CITY OF ALBUQUERQUE

**RE: American Toyota
5995 Alameda NE
Requested for Permanent C. O. – Not Accepted
Engineers Stamp Date 7/22/15 (C18D012)
Certification dated: 5-29-18**

ENGINEER'S SEAL 7/22/15 DAVID SOULE P.E. #14522	AMERICAN TOYOTA GRADING AND DRAINAGE PLAN <i>Rio Grande Engineering</i> 1806 CENTRAL AVENUE SE SUITE 201 ALBUQUERQUE, NM 87106 (505) 872-0999	DRAWN BY WCWJ
		DATE 7-22-15
		21403-LAYOUT-1-25-14
		SHEET # —
		JOB # 21403

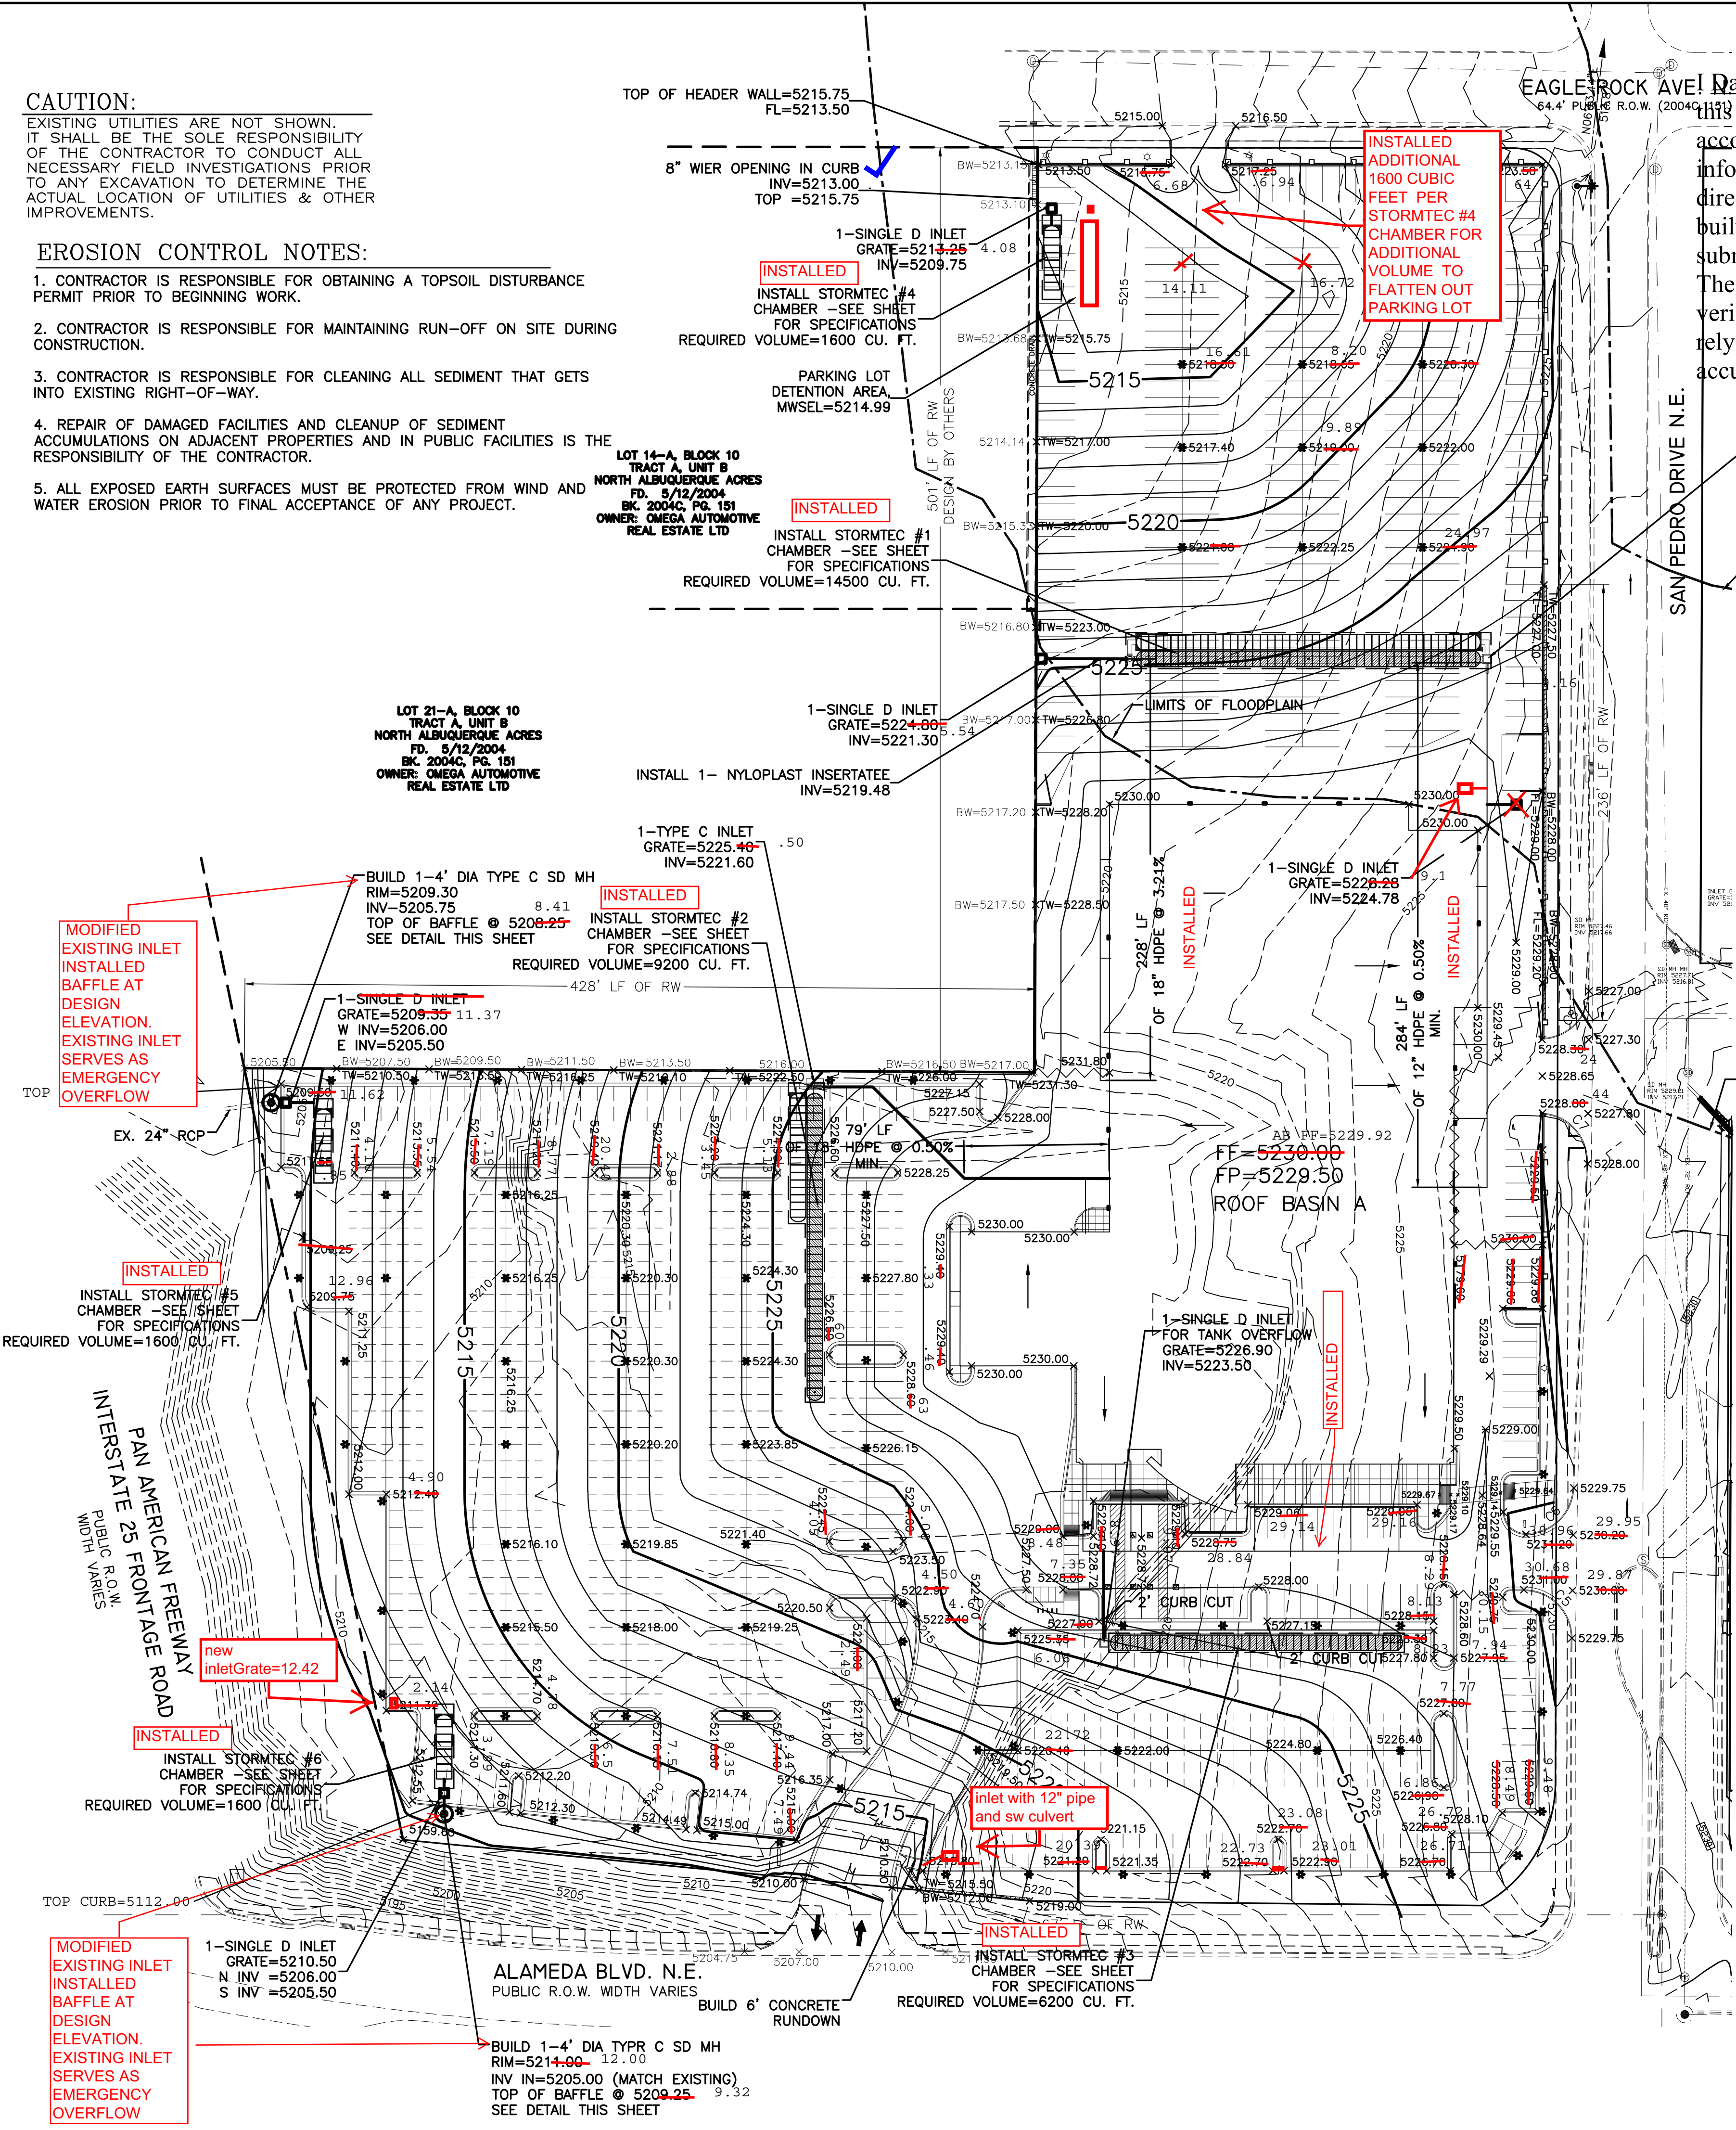
Based on the certification provided in your submittal received 5/29/2018, the above referenced site cannot be accepted for release of Certificate of Occupancy and ROFG by Hydrology until the following comments are addressed:

- The Private Facility Drainage Covenant is required for the maintenance of the first flush facilities.
